Re: 200 Area Hanford, 242-A Evaporator and 241-AW-102 Double Shell Tank (DST) Joint Ecology Air Operating Permit (AOP # 00-05-006) and DOH (FF-01 License) Audit # 820 Inspection on September 18, 2012

**ECOLOGY NUCLEAR WASTE PROGRAM
INSPECTION REPORT**

**Site: 200 Area Hanford, 242-A Evaporator and 241-AW-102 Double Shell Tank (DST),
Audit # 820**

**DEPARTMENT OF HEALTH
INSPECTION REPORT**

242-A Evaporator Drain System

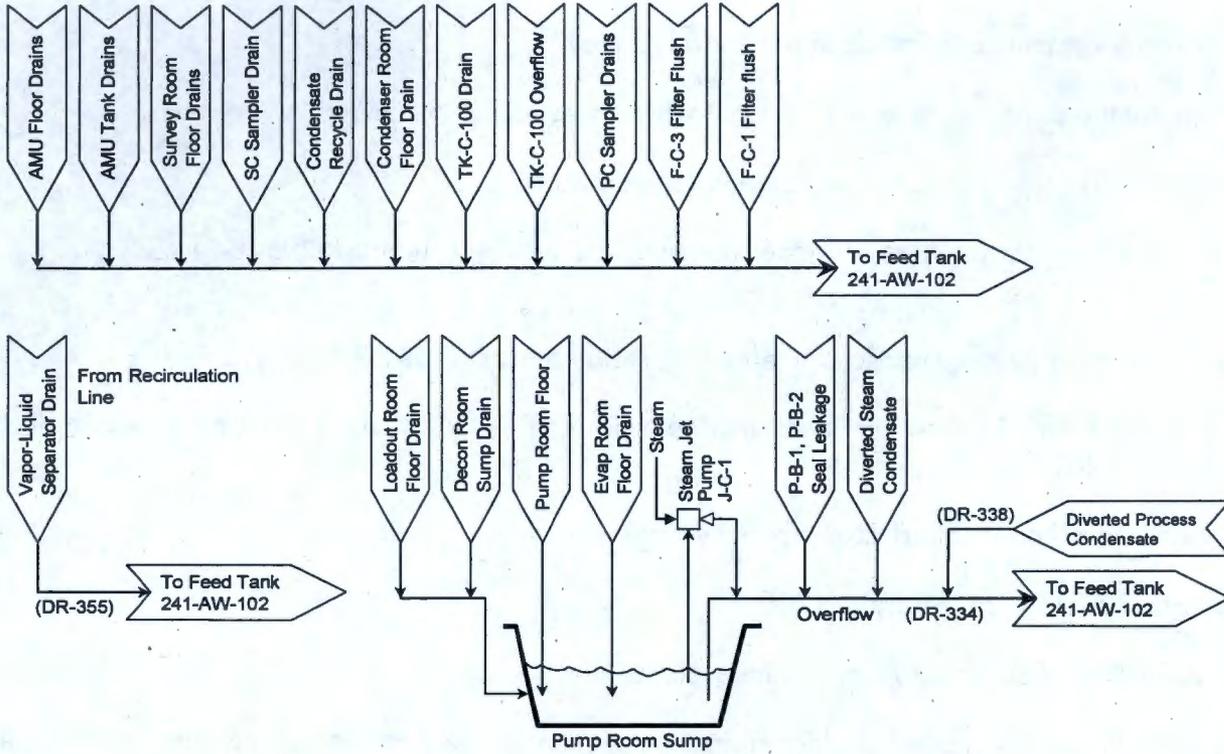
21. After these studies and "air reversal events", have additional valves, seals, vapor leak detection, and/or alarms been added?
22. Are there valving, vapor locks or seals for all of the drain sources as listed in the figure below depicting the drainage system?

23. Are there leak detectors and alarms for both liquid and vapor excursions for all of the drain sources listed in the figure below depicting the drainage system?
